### ADDENDUM NO. 1

To the Drawings and Project Manual dated 16 June 2017

**TAS/ADA FIRE MARSHAL  
DEFERRED MAINTENANCE PROJECTS  
MIDWESTERN STATE  
UNIVERSITY**

Addendum Date: 2 August 2017

**5 PARTIAL SITE PLAN - BOLIN BLDG.**  
B-E201 SCALE: 1" = 60'

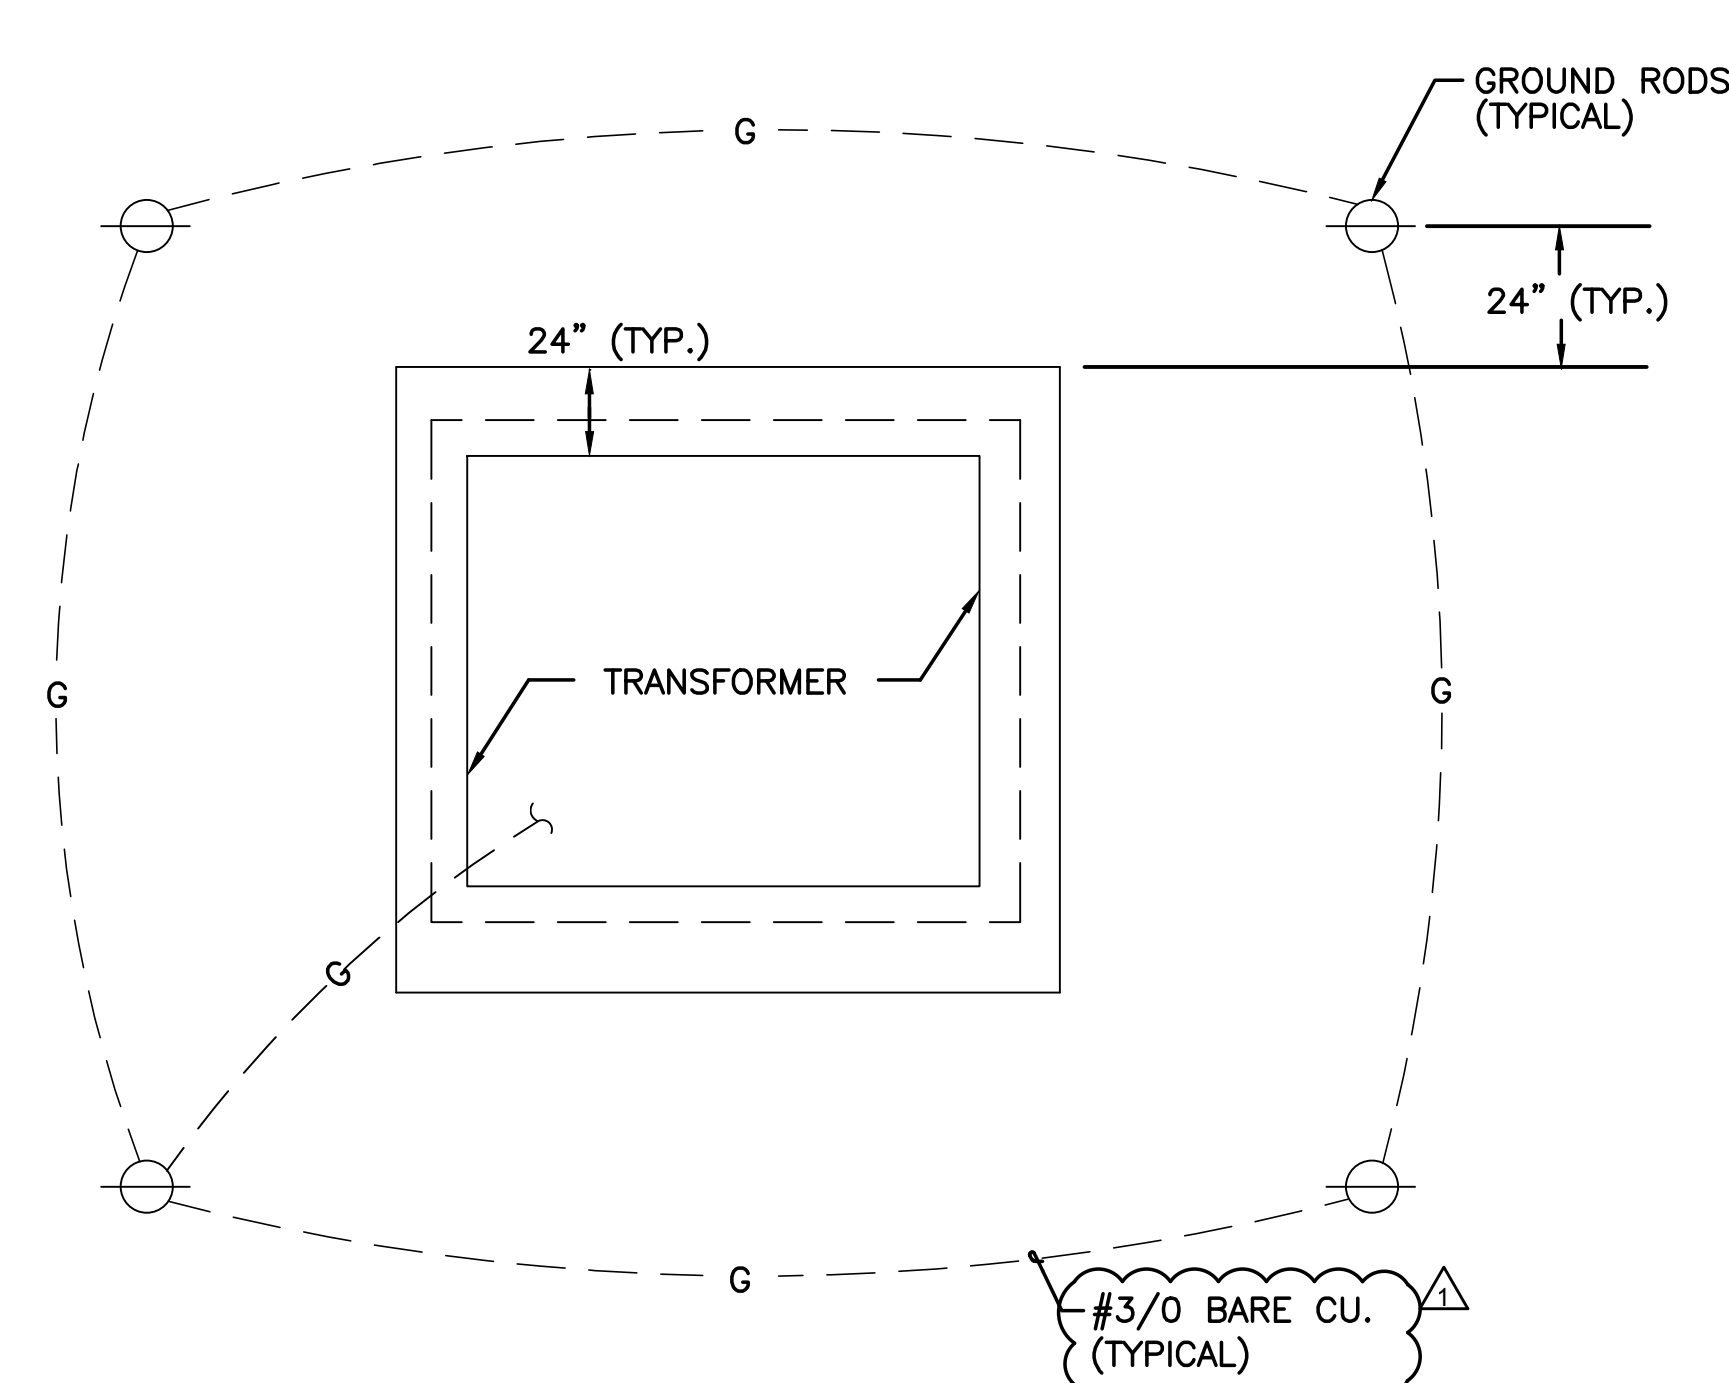
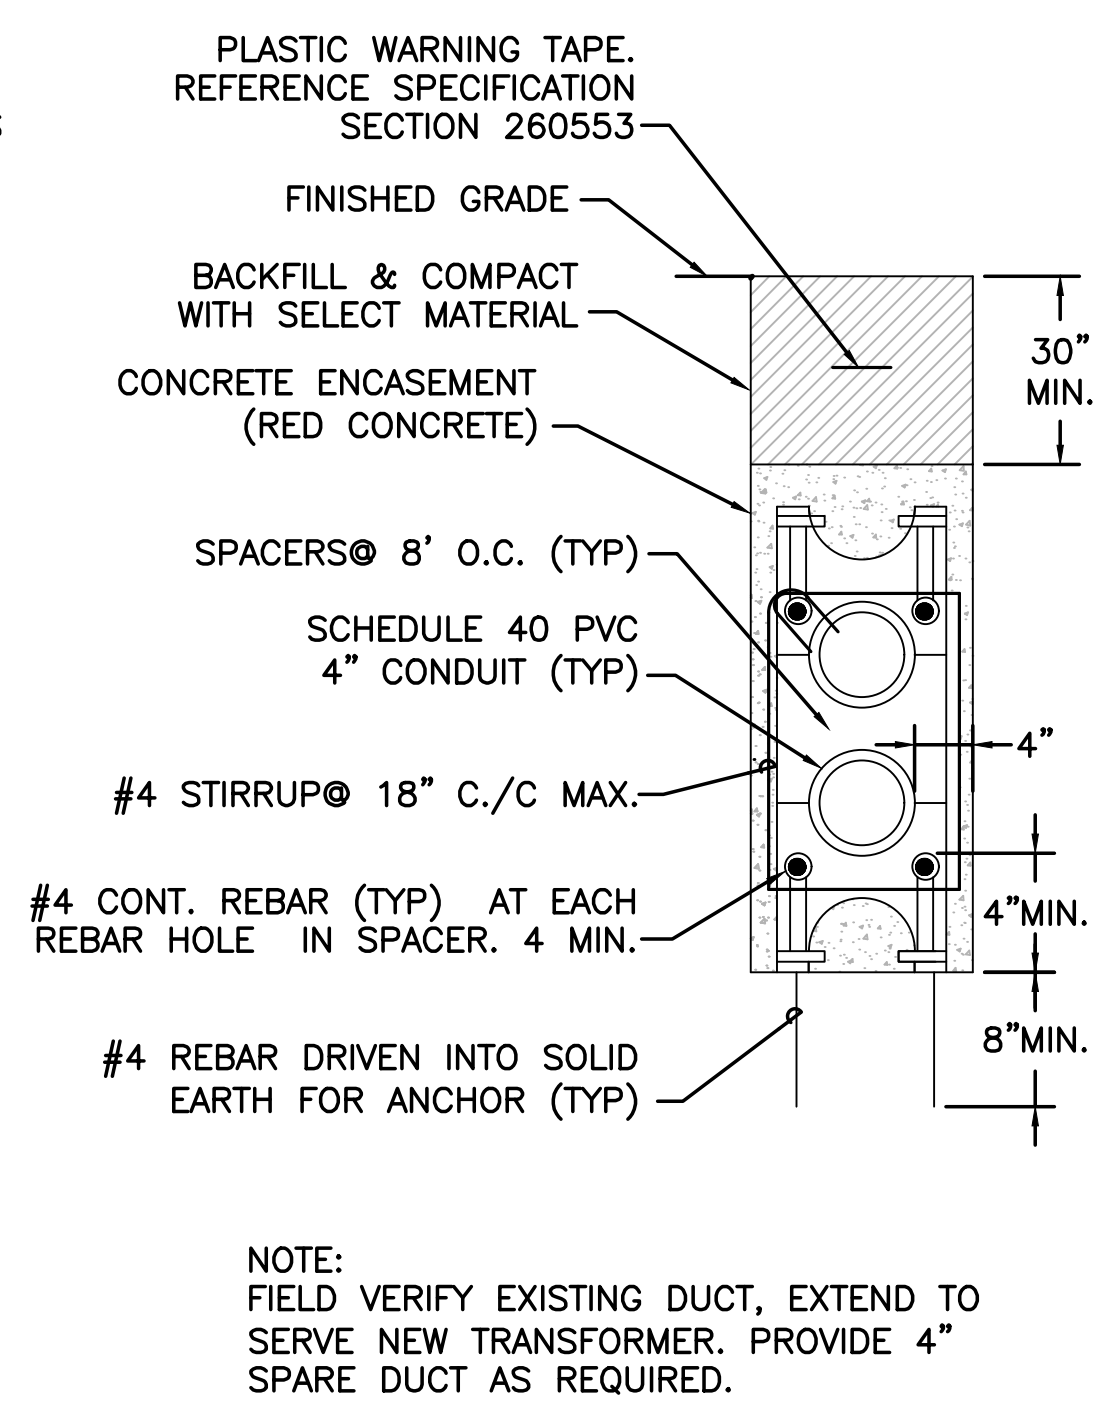
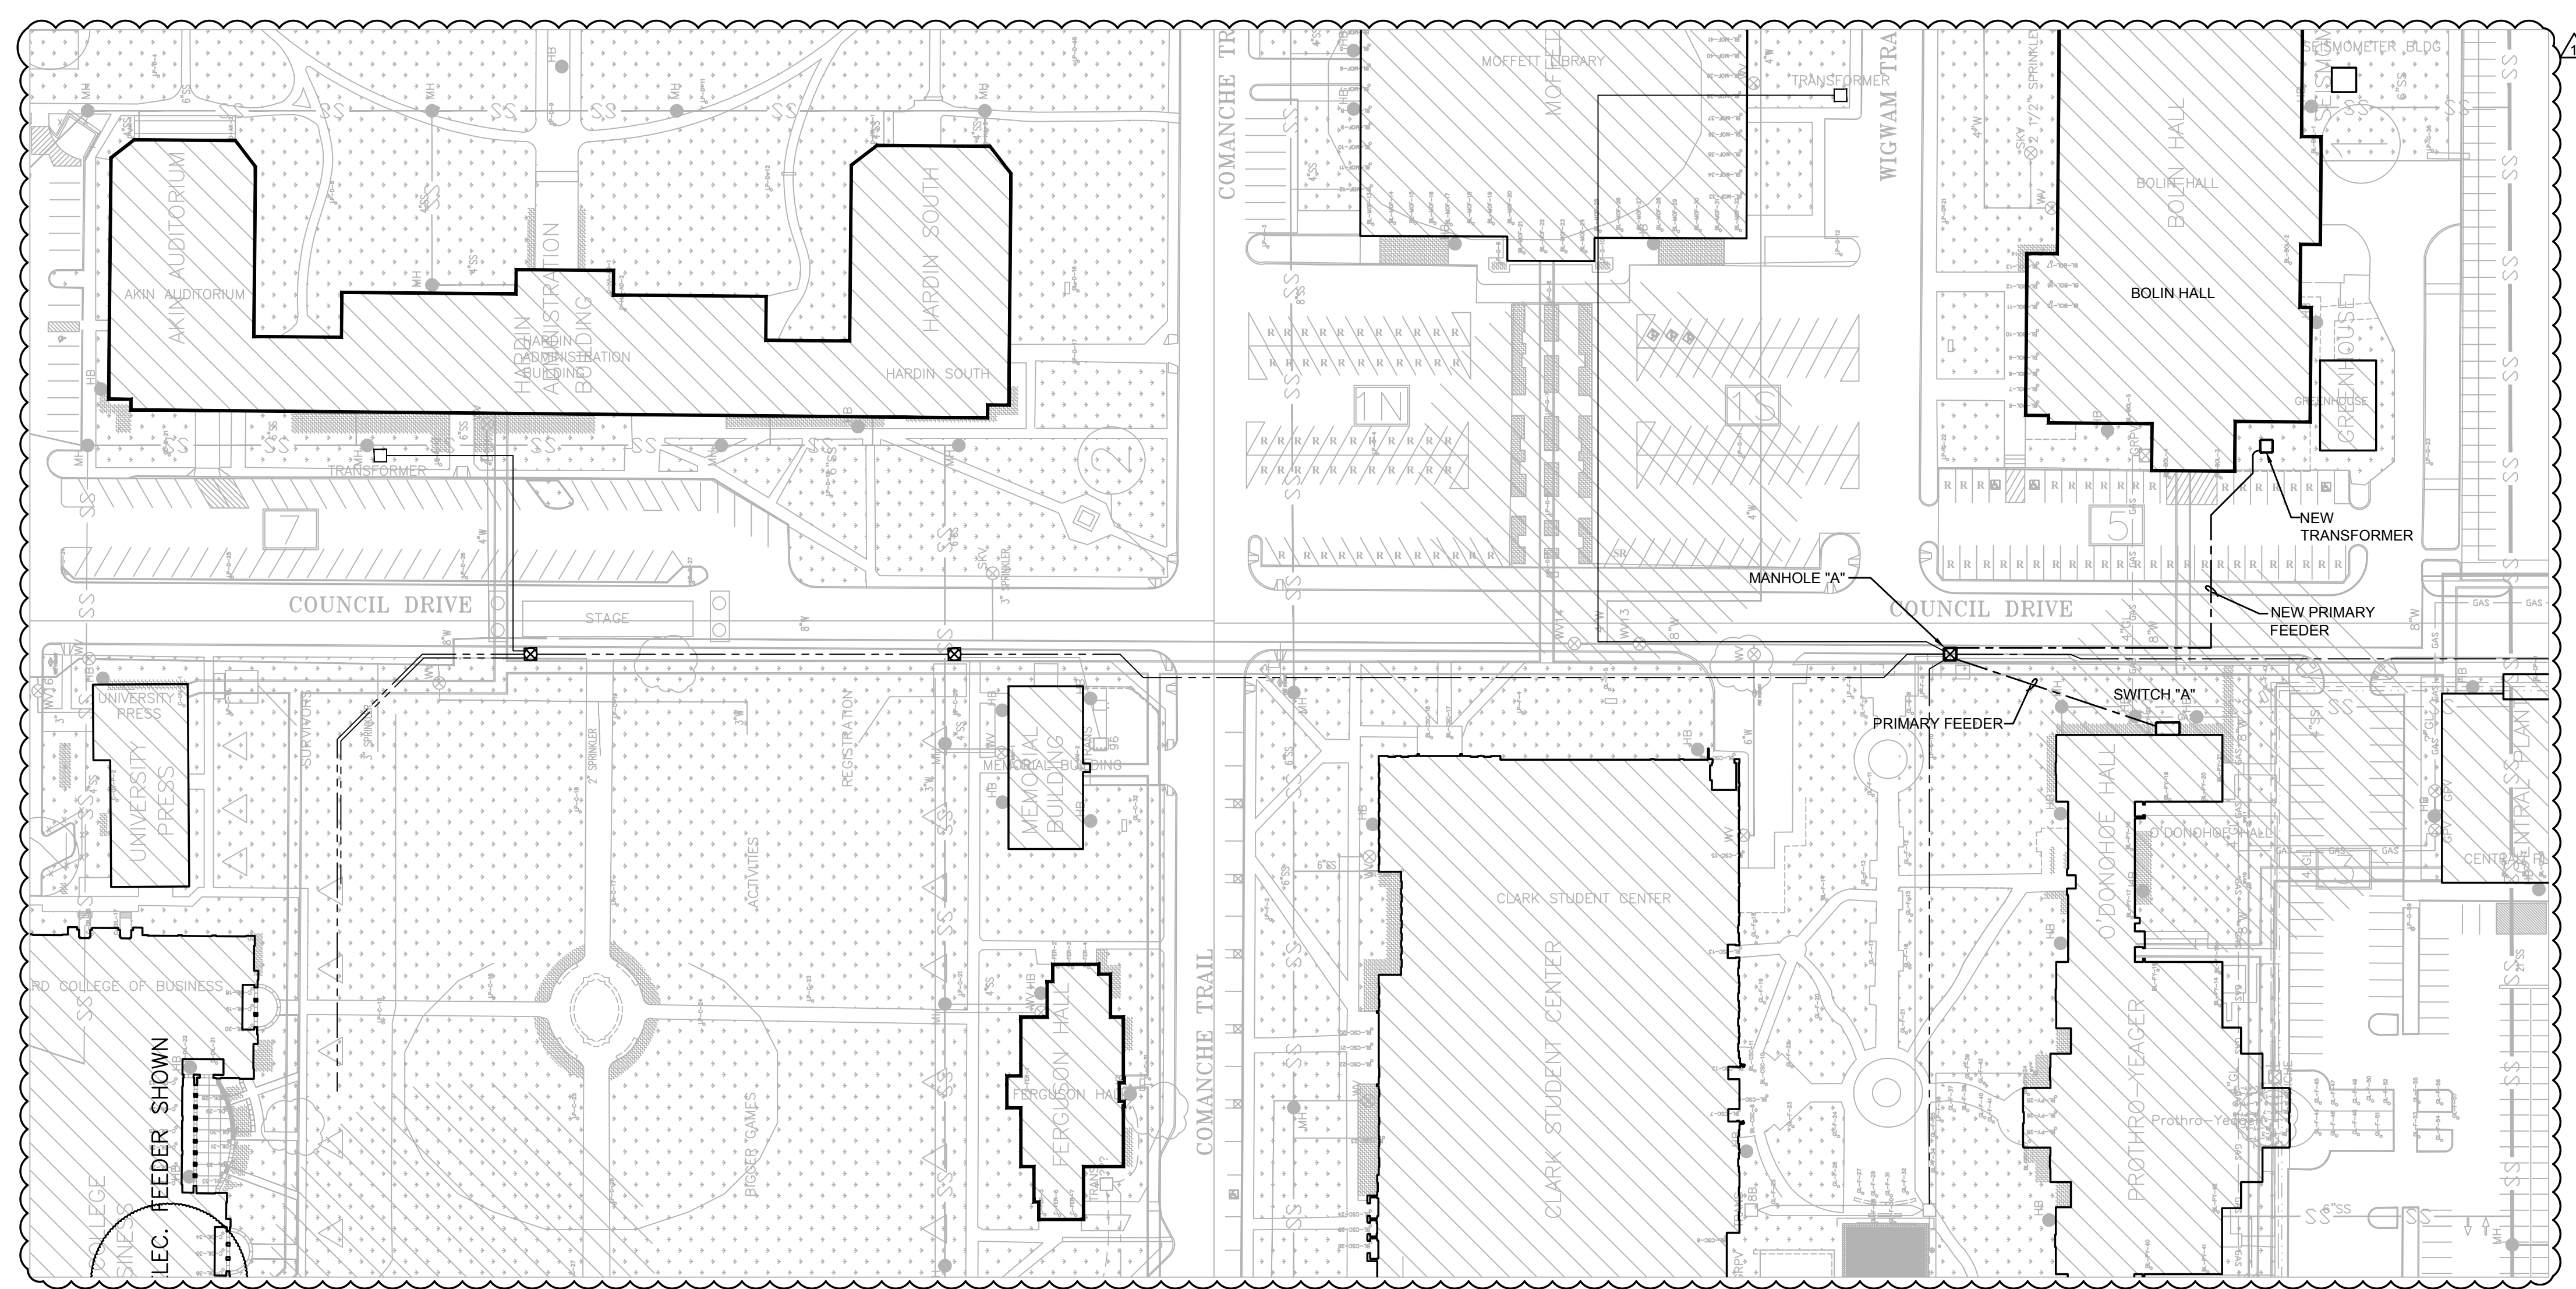
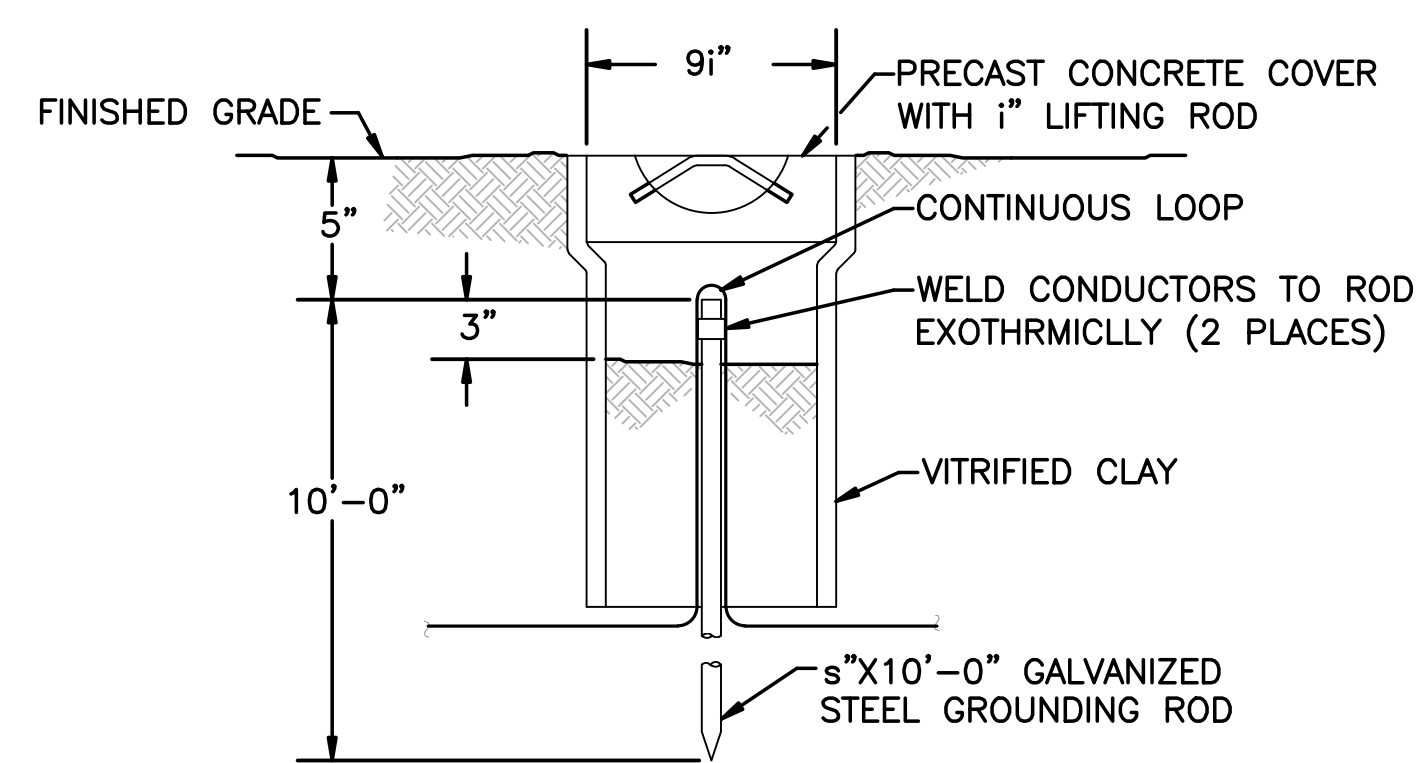
4. Sheet B-E201 – Revised Drawing as follows:
  - a. Added drawing 5/B-E201 Partial Site Plan to indicate location of Switch A.
  - b. Modified details to clarify that there are two primary side conduit, and grounding is 3/0.

- c. Increased the M.C.B. and wiring to 150A for new Kitchen panel “K1”.
5. Sheet H-ED101 – Revised Drawing as follows:
  - a. Indicate that an existing empty conduit is to be cut.
